Access Compliance Report

Public Rights-of-Way

(Curb Ramps)

Intersection ID: 53713	Main Street: N_TRYON_ST	Cross Street: PERIWINKLE_HILL_AV	Location: N
ADA ID: 06224A79585F	Ramp Type: Perp	Initial Pass/Fail: Fail	Overall Compliance: No
Severity Score: 8.75			
Codes/Mitigation Info/Possible Solution		Field Measurements/Component Compliance

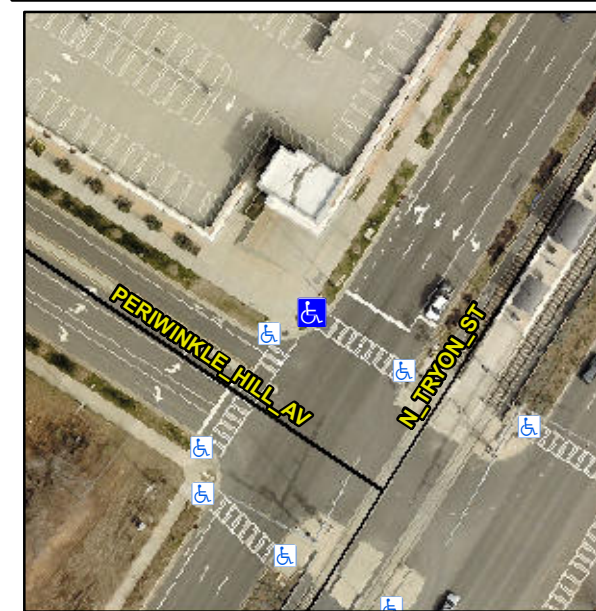
R304.5.1

Compliance	Description	Data	Compliance	Description	Data
N/A	Ramp Length (in)	96.0	Yes	Ramp Slope (%)	6.2
No	Ramp Width (in)	47.0	Yes	Ramp XSlope (%)	1.1
N/A	Flare Type LT	N/A	N/A	Flare Type RT	N/A
N/A	Flare Slope LT (%)	N/A	N/A	Flare Slope RT (%)	N/A
N/A	Flare Traversable LT?	N/A	N/A	Flare Traversable RT?	N/A
N/A	Landing Length (in)	N/A	N/A	DWS Provided?	N/A
N/A	Landing Width (in)	N/A	N/A	DWS Contrast?	N/A
N/A	Landing Slope (%)	N/A	N/A	DWS Length (in)	N/A
N/A	Landing X Slope (%)	N/A	N/A	DWS Full Width?	N/A
N/A	Landing Curb? (Y/N)	N/A	N/A	DWS Offset (in)	N/A
N/A	Shared Landing?	N/A			
N/A	Gutter Ponding?	N/A	N/A	Gutter Slope (%)	N/A
N/A	Gutter Lip Ht (in)	N/A	N/A	Gutter X Slope (%)	N/A
N/A	Painted X Walk1?	Yes	N/A	Painted X Walk2?	N/A
	X Walk 1 Direction	To SE		X Walk 2 Direction	N/A
N/A	X Walk 1 Width (in)	106.0	N/A	X Walk 2 Width (in)	N/A
	X Walk 1 Slope (%)	2.8		X Walk 2 Slope (%)	N/A
	X Walk 1 X Slope (%)	0.5		X Walk 2 X Slope (%)	N/A

Remove & Replace Entire Ramp.
